ADDENDUM NO. 4

SUBJECT: Solicitation No. AA018B

TITLE: Miami International Airport (MIA) South Terminal Concourse H Rehabilitation – Phase 1

ATTACHMENT 1 - Drawing

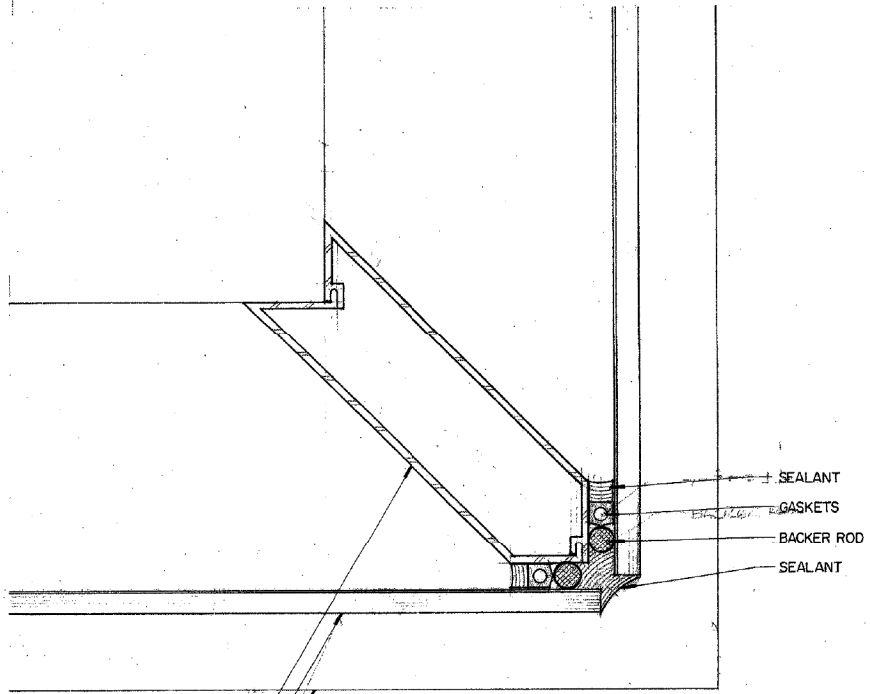
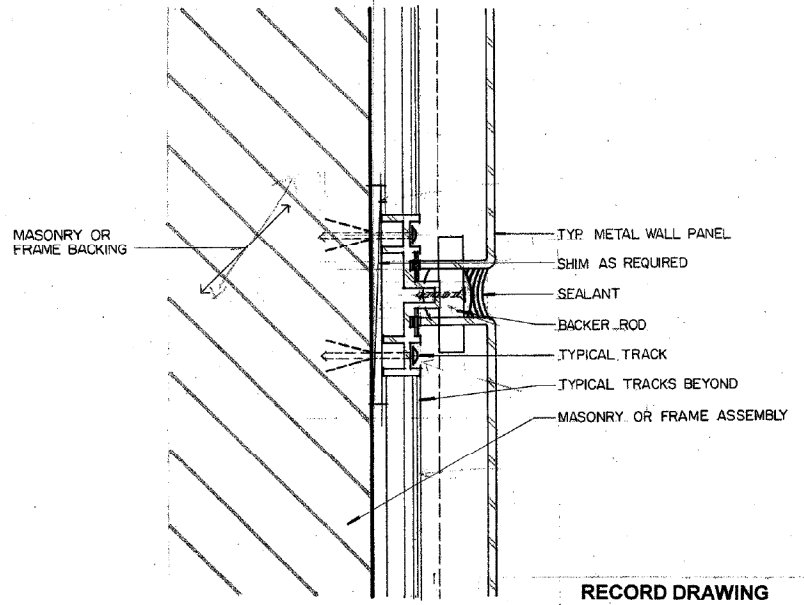
Question No. 2 The curtain walls framing require a vertical tube steel column where the two curtain walls meet at the 90 degrees return to the building. The drawings have not designed, engineered, and sized these steel columns, they are not part of the curtain wall system. Please provide the engineering for these steel tube columns including all required top and bottom connection to the existing structure. Without this information we will not be able to include the cost of these steel columns in our bid.

[Answer No. 2:](#) [Refer to Addendum No 4, Attachment 1.](#)
